CLINTON CITY COUNCIL AGENDA

<p>SUBJECT: 7:15 p.m. – PUBLIC HEARING – RESOLUTION NO. 11-16 Final Plat Approval for Phase 6 of the Cranefield Estates Subdivision located at approximately 3550 West 2350 North</p>	<p>AGENDA ITEM: E</p>
<p>PETITIONER: Ivory Development, represented by Nick Mingo</p>	<p>MEETING DATE: August 9, 2016</p>
<p>RECOMMENDATION: The Planning Commission reviewed and recommended the City Council adopt Resolution No. 11-16 approving the Final Plat for Phase 6 (staff recommends changing the name to Clubview Phase 2 because of different development standards in the agreement) of the Cranefield Estates Subdivision.</p>	<p>ROLL CALL VOTE:</p>
<p>FISCAL IMPACT:</p>	
<p>BACKGROUND:</p> <ol style="list-style-type: none"> 1) The Master Land Use Map in the General Plan shows this area zoned for residential use with the land use designated as A-E Zone Planned Residential Unit Development (PRUD) with 10,000 square foot lots. 2) Clubview Phase 2 of Cranefield is approximately 7.7 acres consisting of 30 lots ranging in size from 6,115 square feet to 11,568 square feet with an average of 8,306 square feet. 3) This Planned Residential Use Development is guided by the Development

Sheet 1 of 2

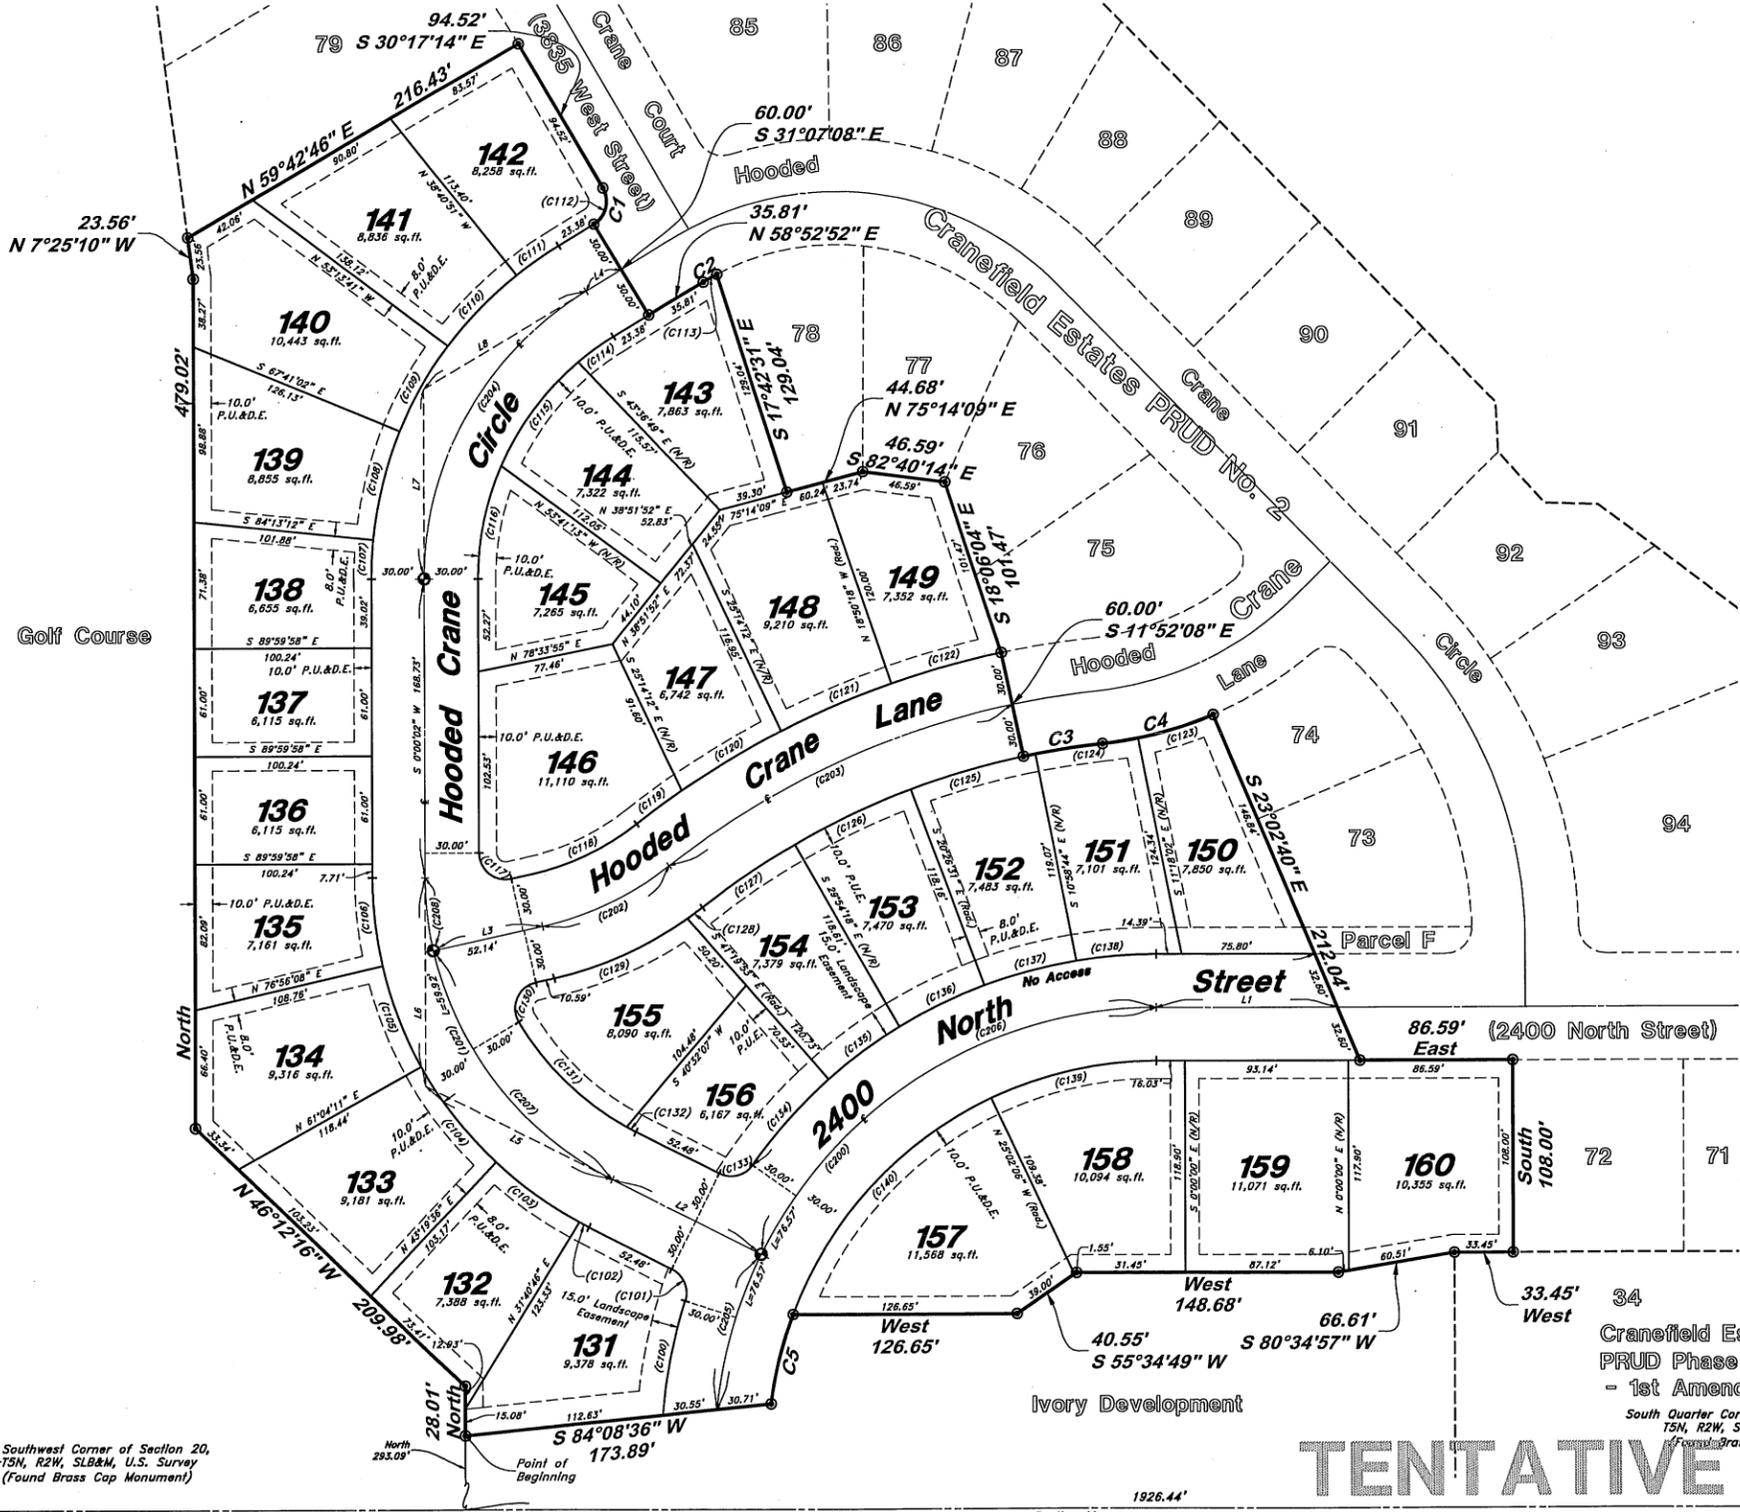
- Fire Hydrant locations: lot 146(SE), between lots 154-153(2400N)
- Submit SWPPP, plan must be approved before a pre construction meeting can be scheduled
- Add restriction to lots 150-154, no access allowed to 2400N
- No waterline details, show valve locations, fire hydrant valves located on the mainline connection
- Adjust alignment of LD, S, W, and Irrigation so they do not overlap each other
- Update standard street design to match pavement design from the geo tec report
- Note contractor to install all traffic and address signage to MUTCD spec's
- Identify signage locations
- Identify blow offs and caps on the dead end 2400N
